Access Compliance Report

Public Rights-of-Way

Intersection ID: 19986	Main Street: ARCHDALE_DR	Cross Street: SOUTH_BV	Location: SW
ADA ID: 78977BE64B18	Ramp Type: Para	Initial Pass/Fail: Fail	Overall Compliance: No
Severity Score: 13.75			
Codes/Mitigation Info/Possible Solution		Field Measurements/Component Compliance

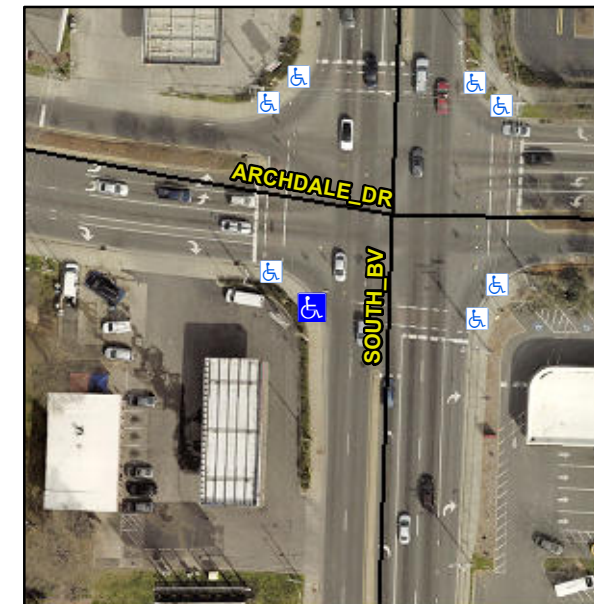
LT RP < 5%

R304.3.2, R304.5.3

Compliance	Description	Data	Compliance	Description	Data
N/A	Ramp Length LT (in)	58.0	N/A	Ramp Length RT (in)	52.5
Yes	Ramp Width LT (in)	92.0	Yes	Ramp Width RT (in)	92.0
Yes	Ramp Slope LT (%)	4.4	No	Ramp Slope RT (%)	10.9
Yes	Ramp XSlope LT (%)	1.8	No	Ramp XSlope RT (%)	3.3
N/A	Landing Length (in)	N/A	N/A	DWS Provided?	N/A
N/A	Landing Width (in)	N/A	N/A	DWS Contrast?	N/A
N/A	Landing Slope (%)	N/A	N/A	DWS Length (in)	N/A
N/A	Landing X Slope (%)	N/A	N/A	DWS Full Width?	N/A
N/A	Landing Curb? (Y/N)	N/A	N/A	DWS Offset (in)	N/A
N/A	Shared Landing?	N/A			
N/A	Gutter Ponding?	N/A	N/A	Gutter Slope (%)	N/A
N/A	Gutter Lip Ht (in)	N/A	N/A	Gutter X Slope (%)	N/A
N/A	Painted X Walk1?	Yes	N/A	Painted X Walk2?	N/A
	X Walk 1 Direction	To E		X Walk 2 Direction	N/A
N/A	X Walk 1 Width (in)	112.0	N/A	X Walk 2 Width (in)	N/A
	X Walk 1 Slope (%)	0.6		X Walk 2 Slope (%)	N/A
	X Walk 1 X Slope (%)	2.5		X Walk 2 X Slope (%)	N/A
N/A	Ramp inside XWalk1?	Yes	N/A	Ramp inside XWalk2?	N/A

Remove & Replace Entire Ramp.
